UNITED STATES PATENT AND TRADEMARK OFFICE

Office Action Summary	Application No. 10/706,410	Applicant(s) WOLFE ET AL.	
	Examiner Kimberly S. Smith	Art Unit 3644

DETAILED ACTION

***Fig. 2***

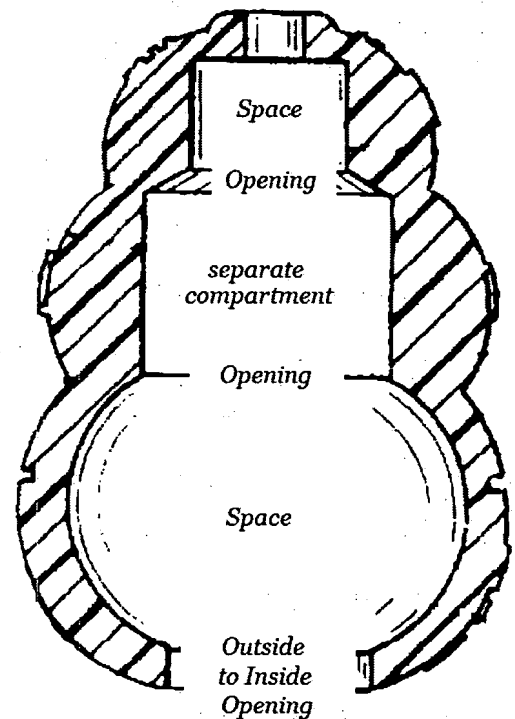
3. This application currently names joint inventors. In considering patentability of the claims under 35 U.S.C. 103(a), the examiner presumes that the subject matter of the various claims was commonly owned at the time any inventions covered therein were made absent any evidence to the contrary. Applicant is advised of the obligation under 37 CFR 1.56 to point out the inventor and invention dates of each claim that was not commonly owned at the time a later invention was made in order for the examiner to consider the applicability of 35 U.S.C. 103(c) and potential 35 U.S.C. 102(e), (f) or (g) prior art under 35 U.S.C. 103(a).
4. Claims 13, 16, 17 and 19-21 are rejected under 35 U.S.C. 103(a) as being unpatentable over Markham, US Patent 6,439,166 in view of Rucker, US Patent 6,634,318 in view of Costello, US Patent 6,148,771.

Markham discloses a ball (reference instant specification page 6 defining a ball to be inclusive of cylindrical, oblong or the like) with an outside and an inside including a separate

compartment having two openings and an opening from the outside to the inside of the ball (reference inserted Figure), wherein the separate compartment is offset from a center location of the ball (as the center location being defined as the midpoint of the ball from the top to the bottom). However, Markham does not disclose a removable edible cap in the at least one opening. Rucker teaches within the same field of endeavor the use of a removable edible cap for closing an opening so as to contain the treats within the toy for a longer period of time thereby increasing the length of time for enjoying the toy. It would have been obvious to one having ordinary skill in the art at the time the invention was made to use the cap as taught by Rucker with the apparatus of Markham so as to prolong the enjoyment for the animal. Markham in view of Rucker further does not teach the use of a flap limiting the size of an opening. Costello teaches flaps (41) so as to

Regarding claim 17, Markham discloses the use of a funnel section (i.e. the funnel located between the top space and the separate compartment) but does not disclose a second funnel section in the second opening. It would have been obvious to one having ordinary skill in the art at the time the invention was made to use a second funnel section in the second opening,

Markham discloses a ball (reference instant specification page 6 defining a ball to be inclusive of cylindrical, oblong or the like) with an outside and an inside including a separate compartment having two openings and an opening from the outside to the inside of the ball (reference inserted Figure above), wherein the separate compartment is offset from a center
